Attachment A

Existing Technical Specifications

Attachment B

Proposed Technical Specifications

Figure 3.1-1

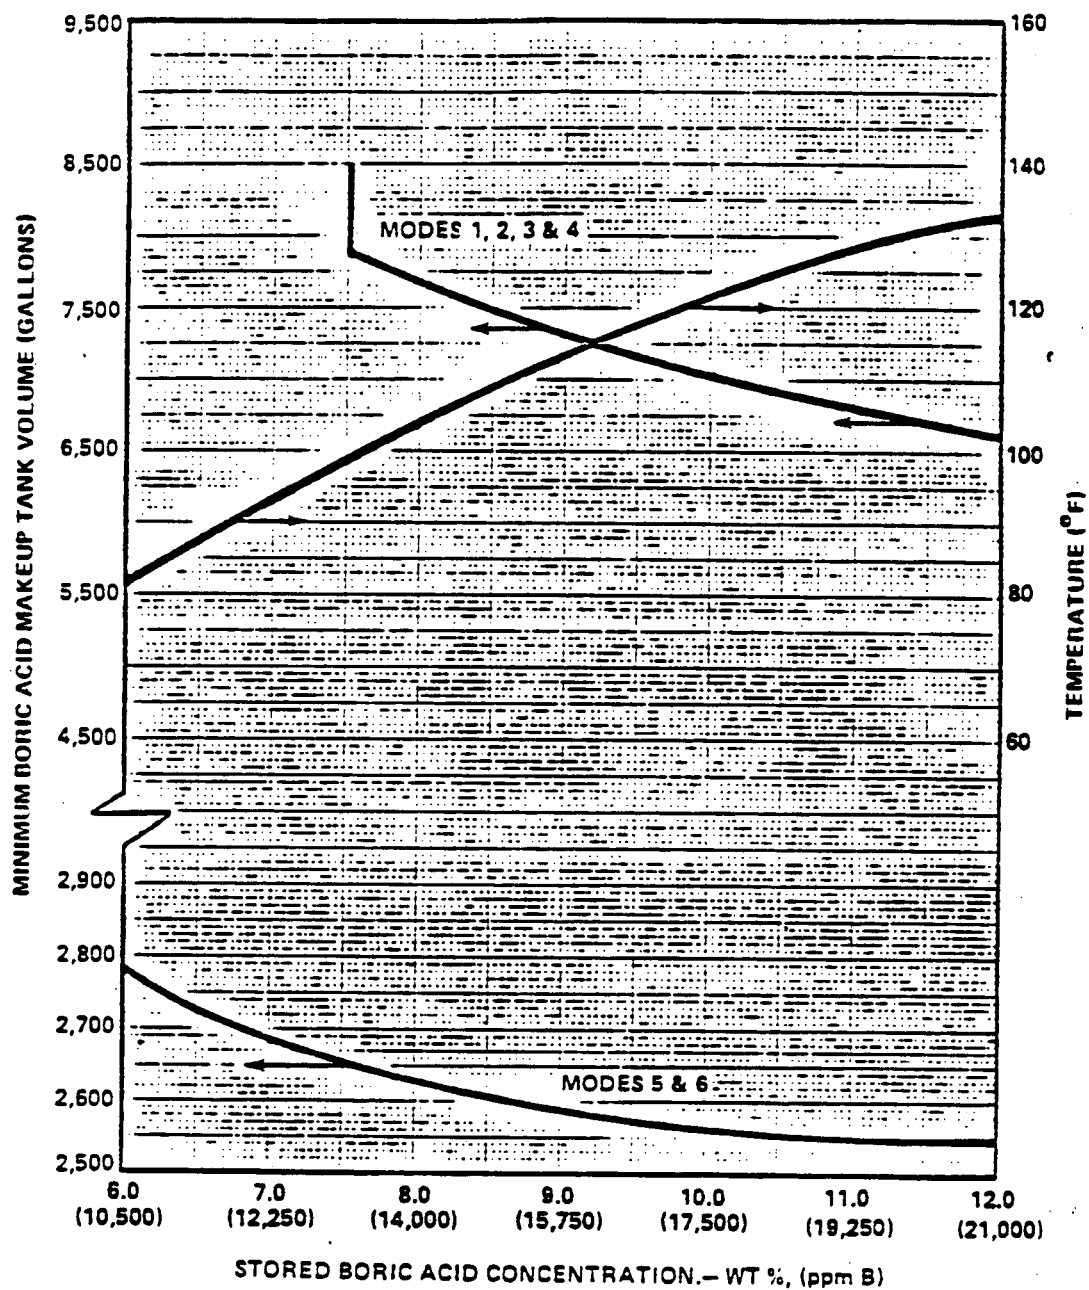
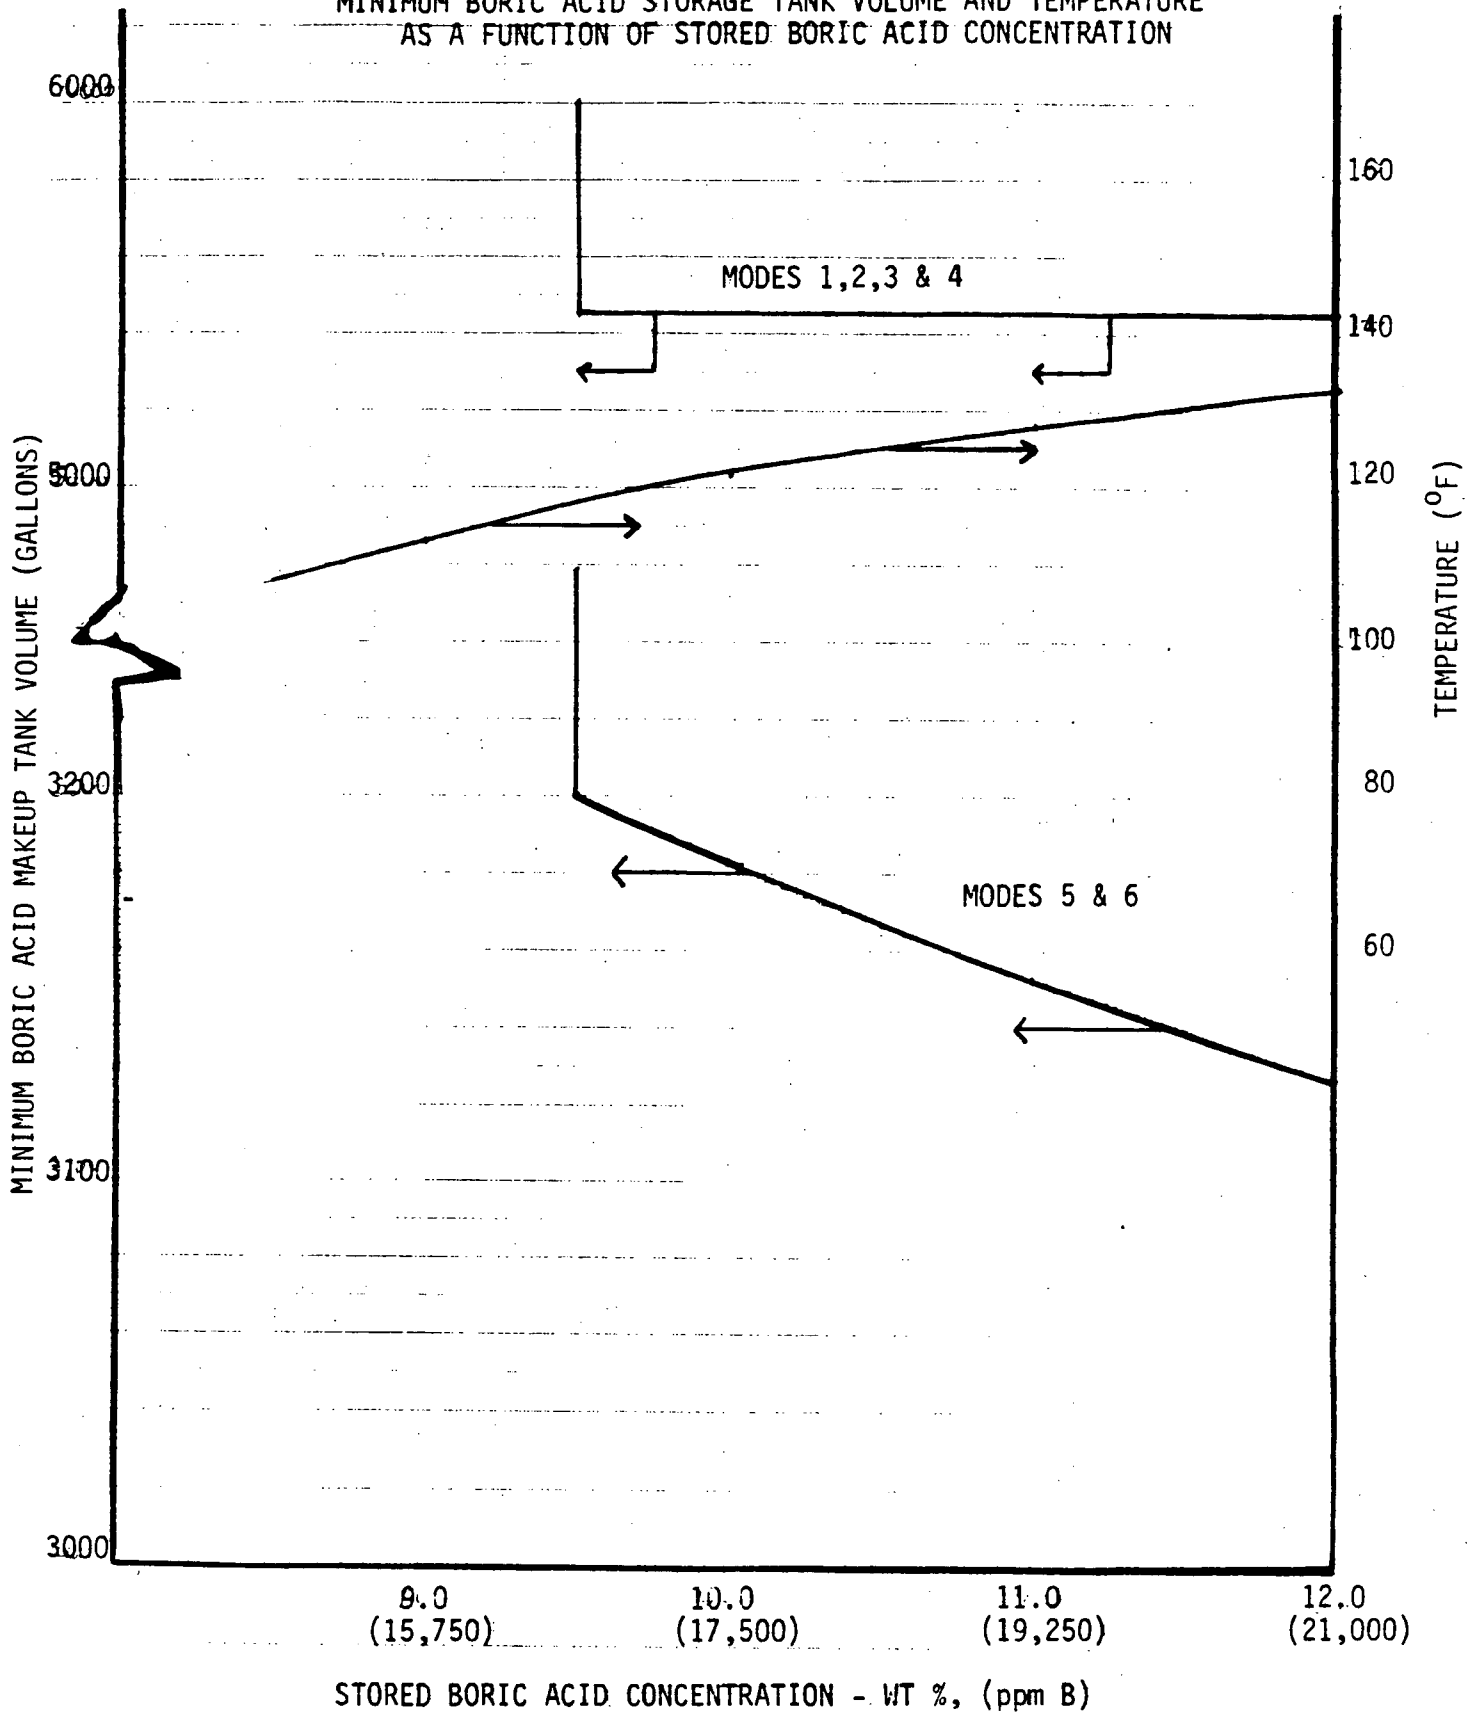
- a. One boric acid makeup tank and at least one associated heat tracing circuit with the tank contents in accordance with Figure 3.1-1.
- b. The refueling water storage tanks with:
 1. A minimum borated water volume of 9970 gallons above the ECCS suction connection,
 2. A minimum boron concentration of 1720 ppm, and
 3. A solution temperature between 40°F and 100°F.

The boron capability required below 200°F is based upon providing a 2% delta k/k SHUTDOWN MARGIN after xenon decay and cooldown from 200°F to 140°F. This condition requires either 9970 gallons of 1720 ppm borated water from the refueling water tank or boric acid solution from the boric acid makeup tanks in accordance with the requirements of Specification 3.1.2.7.
